Title: TFCI in the case of invalid transport blocks

Document for: Decision

CHANGE REQUEST		Please see embedded help file at the bottom of this page for instructions on how to fill in this form correctly.	
25.211	CR	083	Current Version: 3.4.0 draft
GSM (AA.BB) or 3G (AA.BBB) specification number ?		? CR number as allocated by MCC support team	
For submission to: RAN #9 <small>list expected approval meeting #here ?</small>	for approval <input checked="" type="checkbox"/> for information <input type="checkbox"/>	strategic <input type="checkbox"/> non-strategic <input type="checkbox"/>	(for SMG use only)

25.212 CR 095

Figure 1: Frame structure for uplink DPDCH/DPCCH

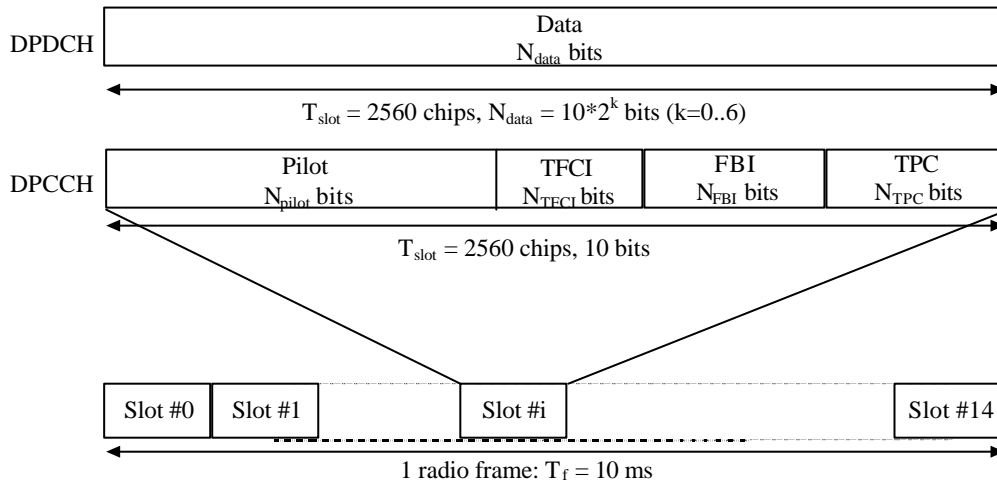
A power control preamble may be used for initialisation of a DCH. Both the UL and DL DPCCHs shall be transmitted during the power control preamble. The length of the power control preamble is a UE-specific higher layer parameter, N_{pcp} (see [5], section 5.1.2.4), signalled by the network. The UL DPCCH shall take the same slot format in the power control preamble as afterwards, as given in table 2. When, $N_{\text{pcp}} > 0$ the pilot patterns from slot # $(15 - N_{\text{pcp}})$ to slot #14 of table 3 and table 4 shall be used. The timing of the power control preamble is described in [5], subclause 4.3.2.2. ~~The TFCI field is filled with "1" bits.~~

If either no transport blocks, or an invalid set of transport blocks, have been provided to Layer 1, the TFCI code word shall be determined as follows: If a Transport Format Combination with no transport blocks is valid for that radio link,

then the corresponding TFCI code word shall be used, otherwise the TFCI code word shall be generated by setting the input to the TFCI channel coder to all "1" bits(see [3]).

Figure 9: Frame structure for downlink DPCH

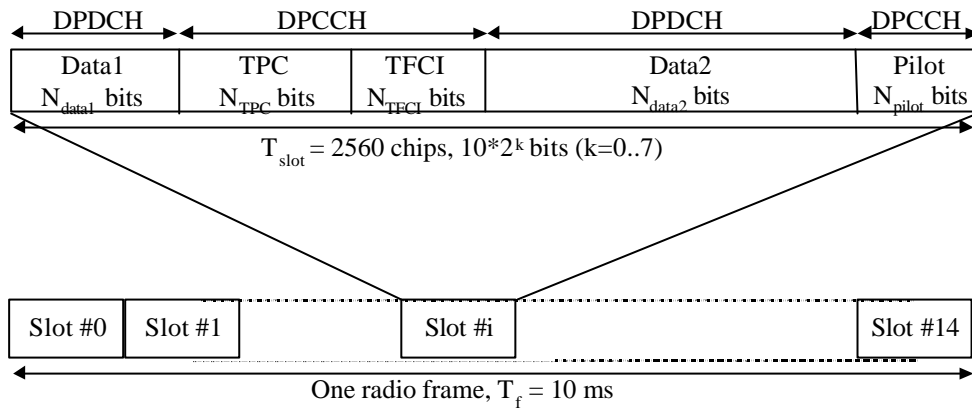
NOTE3: As specified in [15], if TFCI bits are being used and if either no transport blocks, or an invalid set of transport blocks, have been provided to Layer 1, the TFCI field shall be filled as follows: If a Transport Format Combination with no transport blocks is valid, then the corresponding TFCI code word shall be used, otherwise the DTX shall be used in the TFCI field

Figure 10: Channel coding of split mode TFCI information bits

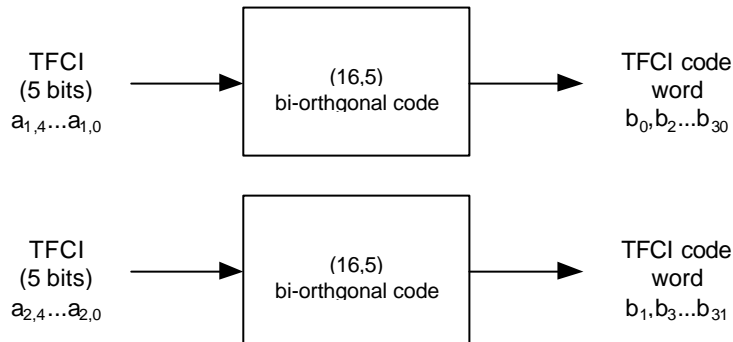
If an invalid set of transport blocks (i.e. which does not correspond to one of the transport format combinations defined for that radio link) is provided to Layer 1, the TFCI code words shall be generated by setting all the input bits to both TFCI channel coders to "1".
